Mercedes-Benz

Date: June 2015
Action No.: C1A 15 06 01
Group: 68

SUBJECT: **Model 205 (C-Class)**
Model Year 2015
Replace Instrument Panel

Customer ONE Action

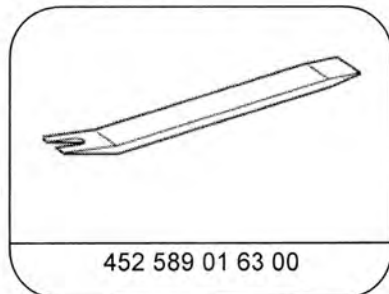
Be sure to replace:

- Self-locking bolt securing steering wheel to steering column and
- Wiring harness lock securing the harness connector to the steering module connector.
(The above parts will be included in parts kit.)
